## PRODUCT UPDATE

Main (707) 578-8811 Toll Free (800) 444-5366 Fax (707) 578-0869 Email info@lemousa.com Number: #127E

## NEW! LEMO Elbow Plugs (00, B, S, K & E) FHG.0B.30#.xxxxxx changes to FPG.0B.30#.xxxxxx

LEGACY NEW

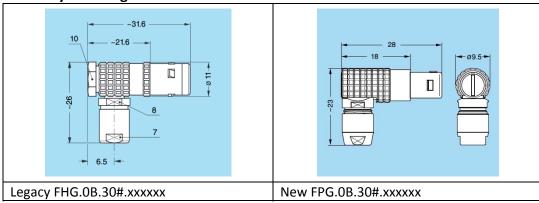
(This change includes all keyways)

- Shorter overall length 31.6mm to 28.0mm
- Smaller body diameter 11mm to 9.5mm
- Same receptacle compatibility as FHG.0B.30#.xxxxxx
